Transport for NSW

Central Precinct Western Gateway (Block C) Rezoning Proposal

Response to Submissions Report

July 2021 | FINAL

Figure 5. Comparison of north-east corner upper level setback between reference scheme and 10m setback requirement set out in the Sydney DCP 2012

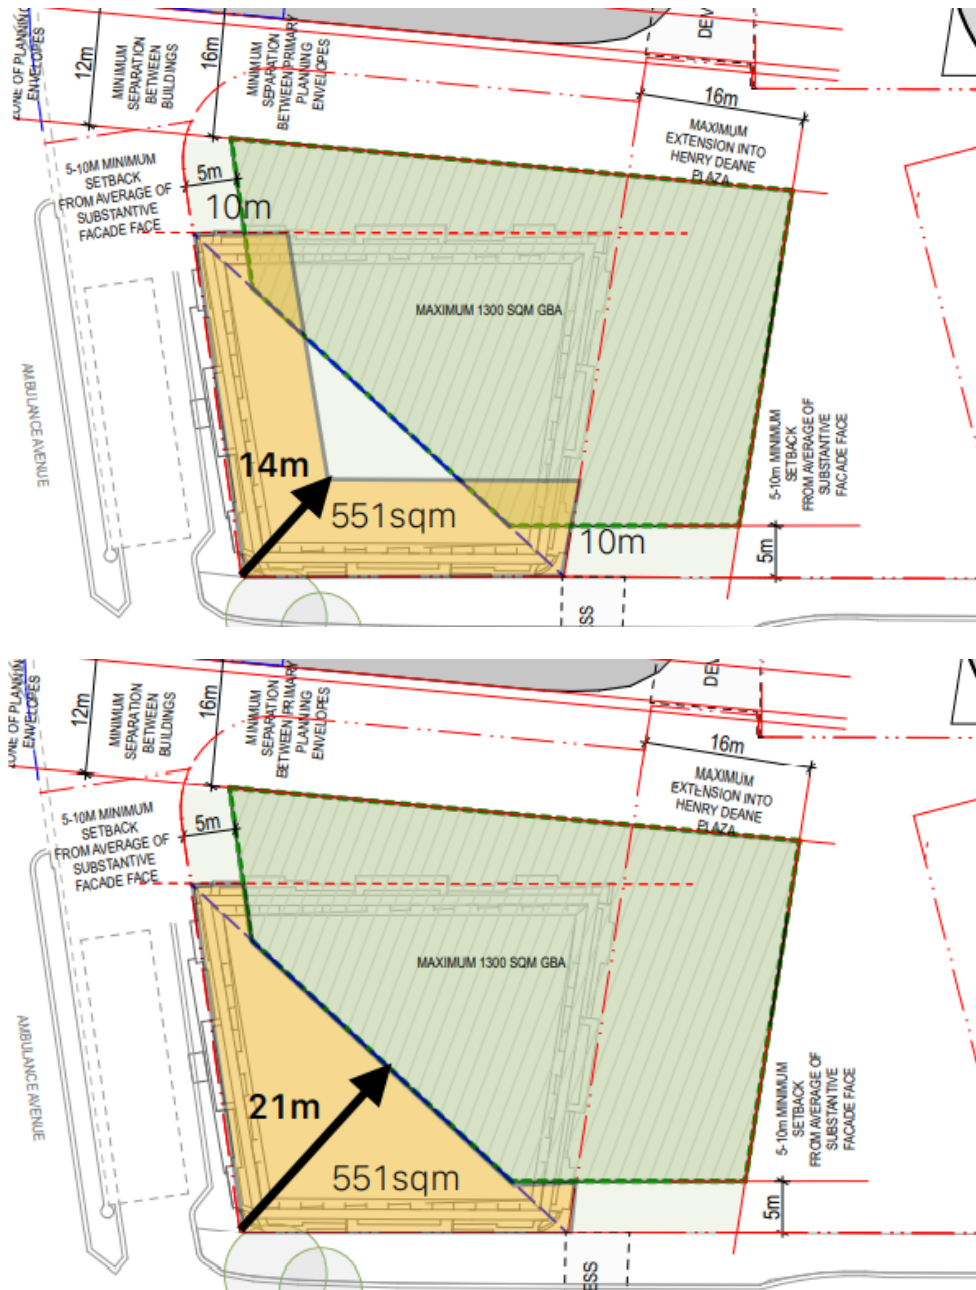
The 5-10m setbacks adopted at the north and west façades was derived through an assessment of the appropriate setback distance required to preserve the primacy of the former Parcels Post Office building when viewed from key public view corridors.

Following the receipt of submissions, the proponent has undertaken further testing and analysis of the proposed northern and western setbacks with the 10m setback requirements set out in the Sydney DCP 2012. An extract of that comparison is provided at **Figure 5** (next page) demonstrating the increased setback from 14 metres to 21 metres from the north-west corner of the former Parcels Post Office building, which will better preserve the primacy of the heritage building.

As illustrated by **Figure 5**, when comparing the proposed setbacks to a DCP compliant 10m setback from the north and west facades (such as if the building were on a corner and subject to the Sydney Development Control Plan 2012 provisions), the setback area is comparable. The difference between the two is evident in the very north east and south west corners of the heritage building, where a small area of encroachment within the 10m occurs for a section of the northern and western facades.
